Technical Service Information

THM 4L80-E NEW SHIFT SOLENOIDS

Figure 1

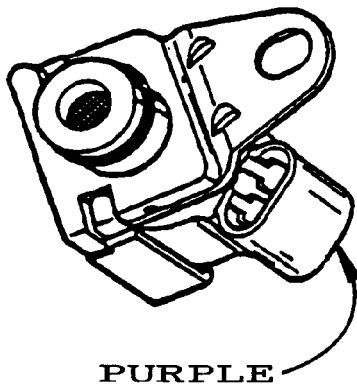
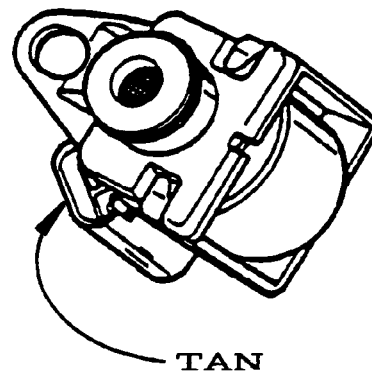
CHANGE: Beginning on November 11, 1993 (Julian Date 315) all THM 4L80-E/4L80-EHD transmissions were built with revised shift solenoid assemblies.

REASON: Revised internal seal material for increased durability.

(1) SHIFT SOLENOID "A" - Revised internal seal material, and is now PURPLE in color, instead of the previous Gray (See Figure 1).

(2) SHIFT SOLENOID "B" - Revised internal seal material, and is now TAN in color, instead of the previous Green (See Figure 1).

The new Shift Solenoids will retro-fit back on ALL previous models of the THM 4L80-E/4L80-EHD transmissions.

Shift Solenoid "A" (PURPLE).....	24201004
Shift Solenoid "B" (TAN).....	24201005
